JOINT REGIONAL PLANNING PANEL (Sydney East Region)

JRPP No	2015/SYE159
DA Number	LDA 2015/538
Local Government Area	City of Ryde
Proposed Development	Demolition of existing buildings and construction of a mixed use development comprising 2 buildings (Block 1 and Block 2) containing a total of 145 residential units & 5,339m ² of car showroom floorspace.
Street Address	589-619 Victoria Road, Ryde
Applicant/Owner	Artro Management Pty Ltd
Number of Submissions	First round notification: Thirty two (32) submissions received Second round notification: Two (2) submissions received
Regional Development Criteria (Schedule 4A of the Act)	General Development over \$20 Million
List of All Relevant s79C(1)(a) Matters	 Environmental Planning and Assessment Regulation 2000; Environmental Planning and Assessment Act 1979; State Environmental Planning Policy (State and Regional Development) 2011; State Environmental Planning Policy No. 55 – Remediation of Land; State Environmental Planning Policy (Building Sustainability Index: BASIX); State Environmental Planning Policy No 65 – Design Quality of Residential Apartment Development; Sydney Regional Environmental Plan (Sydney Harbour Catchment) 2005;

Figure 13: Indicative Plan – Commercial Edge East

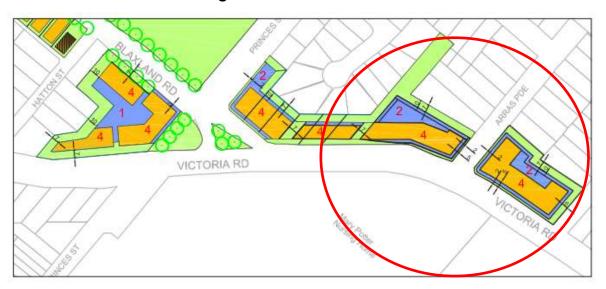
As illustrated in the indicative plan above at Figure 13, controls anticipate the building siting and massing for the subject site (circled in red – referred to as Block 1, west and central parcels and Block 2 eastern parcel). These requirements and the proposal's numerical performance with these are discussed in the **Table 6** below:

Response: The proposed development presents a vastly different built form outcome to that anticipated by the Commercial Edge East indicative plan presented in Figure 13 above.
